Walter Williams - Re: Petition #1244 - Review and Approval

- REQUEST ENCROACHMENT (With Public Art Installation & Bollards)

REQUEST ENCROACHMENT INTO LIVERNOIS AT 19376 - 19384 LIVERNOIS (With Public Art Installation & Bollards)

JOB NO.	01-01	
DRWG. NO.	X 1244

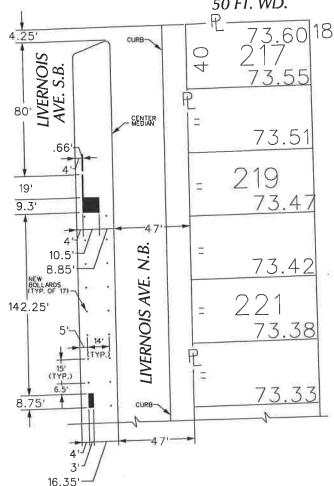
I was looking at the drawing a little closer, and everything looks good except for the piece of the installation furthest north. The black square that is drawn has another frame extension north of the box which is just the width of a 2x8 and is 19' long. I drew a red line on your drawing which is reattached.
